# Accessibility Audit

Prepared by Direct Access Consultancy LLC

June 2024

Westford Town Buildings  
Westford, MA 01886

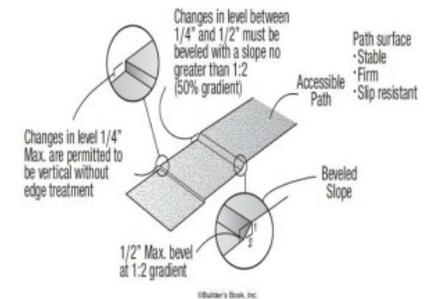
The accessible route contains loose gravel and/or surface materials that do not provide for a stable, firm slip resistant surface.

Replace area where divot and depression impact the ability to travel safely for mobility devices

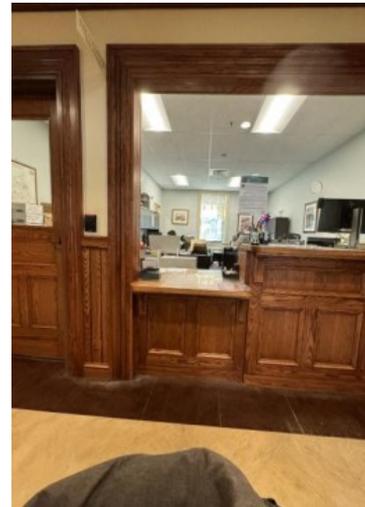
The tactile wall sign is not mounted at the correct height above the floor.

Mounting height shall be 60 inches (60" = 1524mm) above the finish floor to the centerline of the sign.

2006 521 CMR Section 41.2.2  
Mounting height shall be 60 inches (60"= 1524mm) above the finish floor to the center line of the sign.

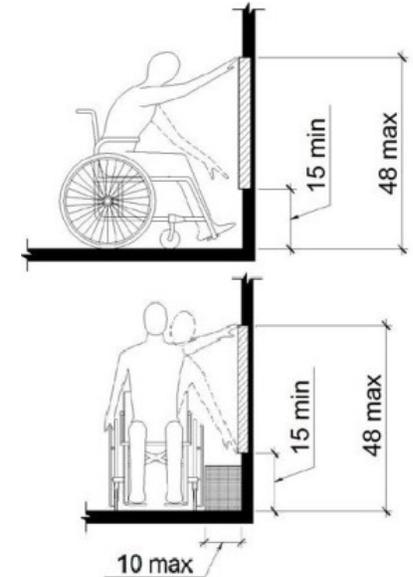
2006 521 CMR Section: 6.5, 6.6

Ensure all mail bins are in an accessible reach range between 15" and 48" above the finished floor.

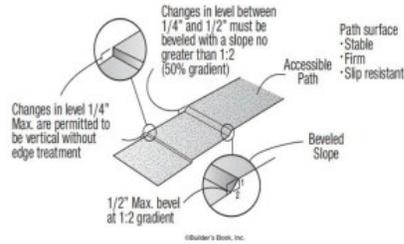
The accessible route contains loose gravel and/or surface materials that do not provide for a stable, firm slip resistant surface.

Repair pavement on accessible route between accessible parking area and accessible entrance.

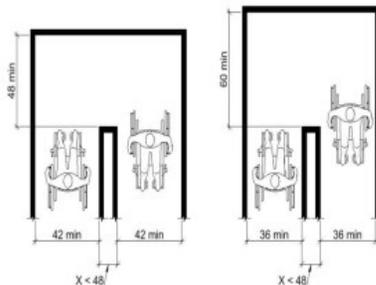
The route of travel does not meet minimum width requirements around the turn.

Where the accessible route makes a 180 degree turn around an element which is less than 48 inches wide, clear width shall be 42 inches minimum approaching the turn, 48 inches minimum at the turn and 42 inches minimum leaving the turn. Where the clear width at the turn is 60 inches minimum a clear width 36 inches minimum approaching the turn and 36 inches minimum at the turn is acceptable.

Where the accessible route makes a 180 degree turn around an element which is less than 48 inches (1220 mm) wide, clear width shall be 42 inches (1065 mm) minimum approaching the turn, 48 inches (1220 mm) minimum at the turn and 42 inches (1065 mm) minimum leaving the turn.

Recommendation: Remove cleaning supplies to ensure that clear floor space that is required is provided

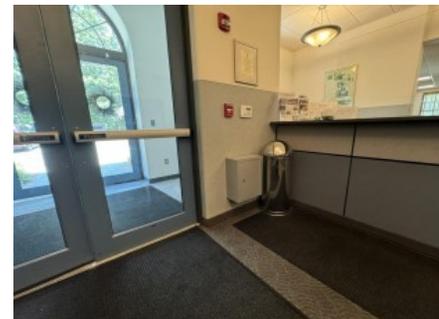
1991 ADAS Section: Advisory

Remove all obstructions from the path of travel approaching the customer service desk.

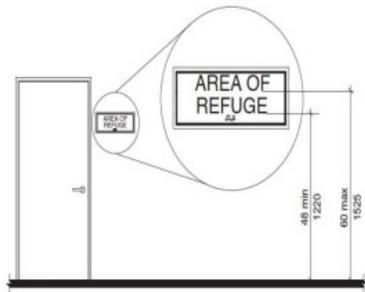
Tactile characters on signs shall be located 48 inches (1220 mm) minimum above the finish floor or ground surface, measured from the baseline of the lowest tactile character and 60 inches (1525 mm) maximum above the finish floor or ground surface, measured from the baseline of the highest tactile character.

2010 ADAS Section: 703.4.1 \$25 - \$150.00

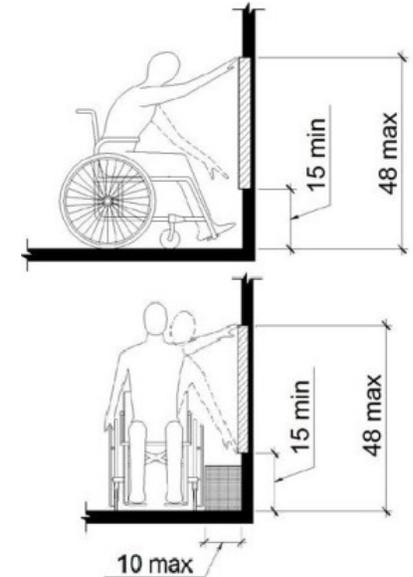
2006 521 CMR Section: 6.5, 6.6

Lower the phone for an accessible reach range

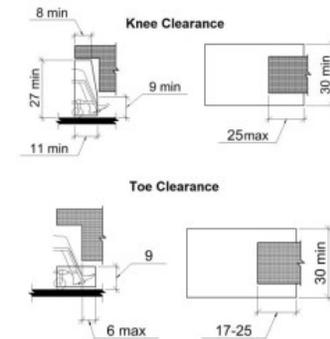
The knee clearance shall be 11 inches deep minimum at 9 inches above the finish floor or ground, and 8 inches deep minimum at 27 inches above the finish floor or ground.

The toe clearance is the space under the sink between the finish floor or ground and 9 inches above the finish floor 30 inches wide minimum. The toe clearance shall extend a minimum of 17 inches and a maximum of 25 inches underneath the sink.

2010 ADAS Section 606.2

A clear floor space complying with 305, positioned for a forward approach, and knee and toe clearance complying with 306 shall be provided.

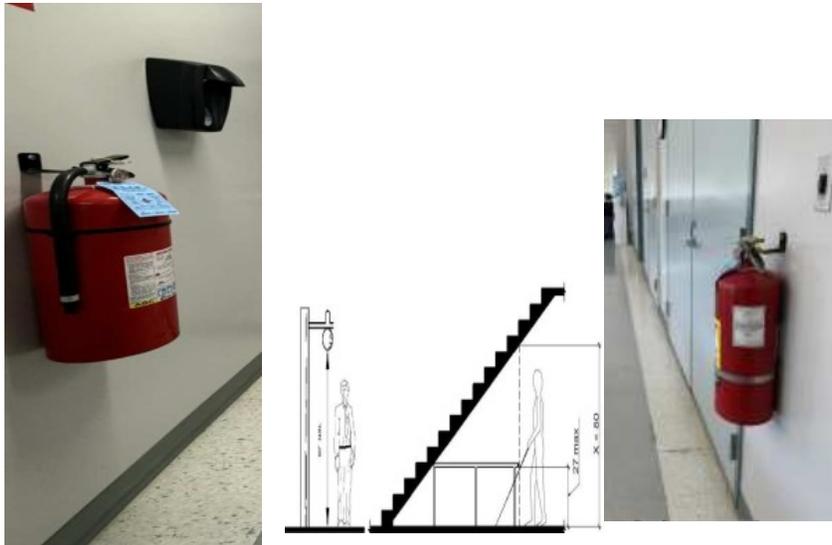
General. Objects projecting from walls (for example, telephones) with their leading edges between 27 in and 80 in (685 mm and 2030 mm) above the finished floor shall protrude no more than 4 in (100 mm) into walks, halls, corridors, passageways, or aisles (see Fig. 8(a)). Objects mounted with their leading edges at or below 27 in (685 mm) above the finished floor may protrude any amount (see Fig. 8(a) and (b)). Free-standing objects mounted on posts or pylons may overhang 12 in (305 mm) maximum from 27 in to 80 in (685 mm to 2030 mm) above the ground or finished floor (see Fig. 8(c) and (d)). Protruding objects shall not reduce the clear width of an accessible route or maneuvering space (see Fig. 8(e)).

Citation: Budgeting Range:
2010 ADAS Section: 307.2 \$500 - \$2,500.00

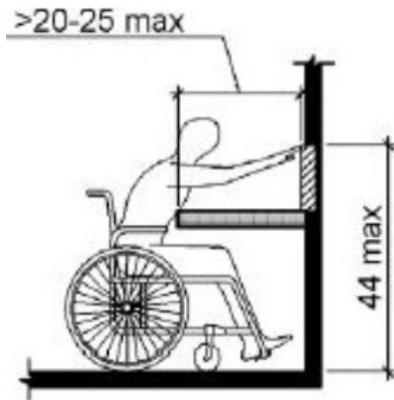
\$150 - \$1,500.00

Lower the paper towel dispenser to bring into an accessible reach range for inclusion purposes.

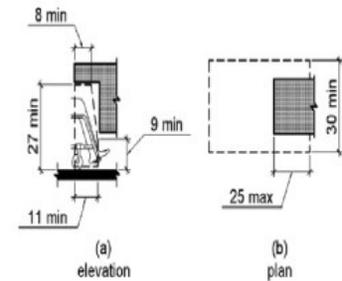
2010 ADAS Section: 606.2, 804.4

Provide required knee and toe space to permit access to the sink.

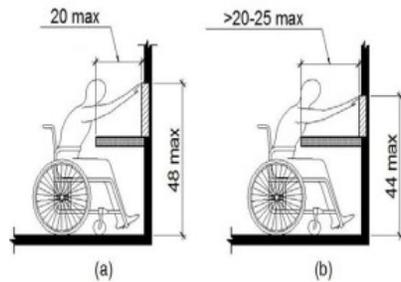
The controls are located such that operation require reaching across burners.

Where knee and toe space is provided, the underside of the range or cooktop shall be insulated or otherwise configured to prevent burns, abrasions, or electrical shock. The location of controls shall not require reaching across burners

2010 ADAS Section 804.6.4

Where a forward approach is provided, the clear floor or ground space shall provide knee and toe clearance complying with 306. Where knee and toe space is provided, the underside of the range or cooktop shall be insulated or otherwise configured to prevent burns, abrasions, or electrical shock. The location of controls shall not require reaching across burners.

Recommendation:  
Replace existing range with a range that has controls on the front to permit someone who uses a mobility device the ability to use the range for inclusion and accessibility purposes,

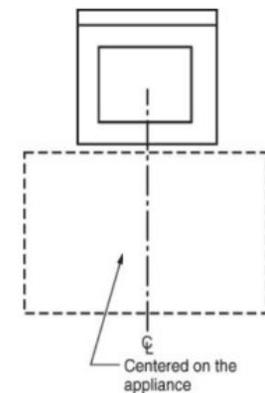
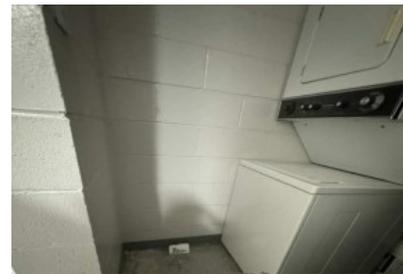
2010 ADAS Section 611.2

A clear floor or ground space complying with 305 positioned for parallel approach shall be provided. The clear floor or ground space shall be centered on the appliance.

Citation: Budgeting Range:  
2010 ADAS Section: 611.2 \$1,500 - \$4,500.00

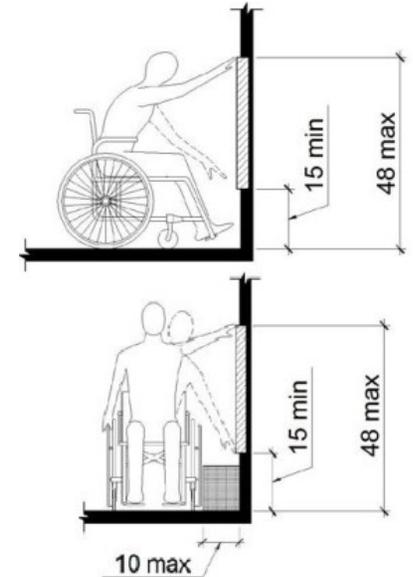
2006 521 CMR Section: 6.5, 6.6

The high reach of the air conditioner is 54 inches above the finished floor and should be lowered to an accessible reach range not to exceed the each range measurements provided above.

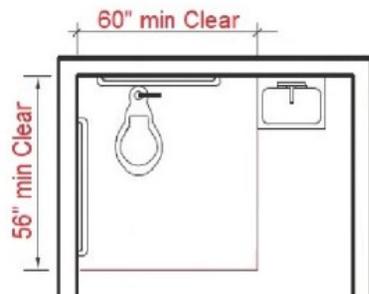
2010 ADAS Section: 604.3.2

Remove Chair that blocks access to toilet for wheelchairs.

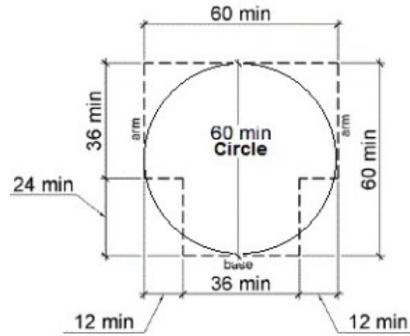
1991 ADAS Section: 4.22.3

Rotate lavatory and sink top allow 60" of space to maneuver into and out of shower

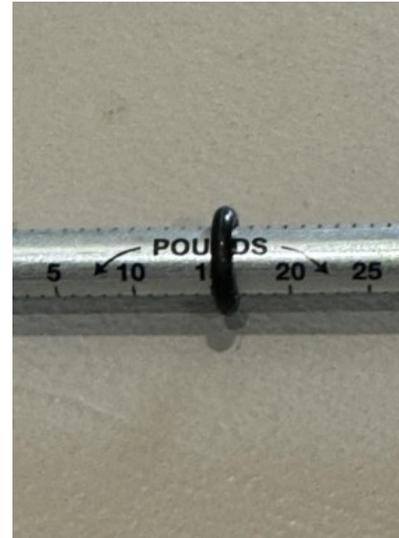
\$25 - \$150.00

Have maintenance decrease the pressure on internal doors so that it's no greater than 5 pounds to open

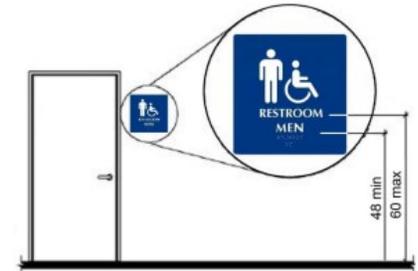
1991 ADAS Section: 4.30.6

Install a compliant Restroom sign with raised lettering, pictogram and braille at the correct height and location.

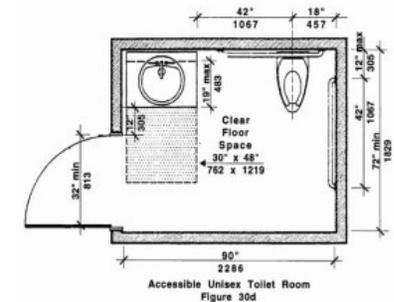
Location: The centerline of the water closet shall be located 18 inches (18"= 457mm) from the nearest side wall and at least 42 inches (42" = 1067mm) from the farthest side wall or the closest edge of an adjacent fixture. There shall be at least 42 inches (42" = 1067mm) clearance between the front edge of the water closet and the nearest wall or fixture.

2006 521 CMR Section: 30.7.2 **\$1,500 - \$6,500.00**
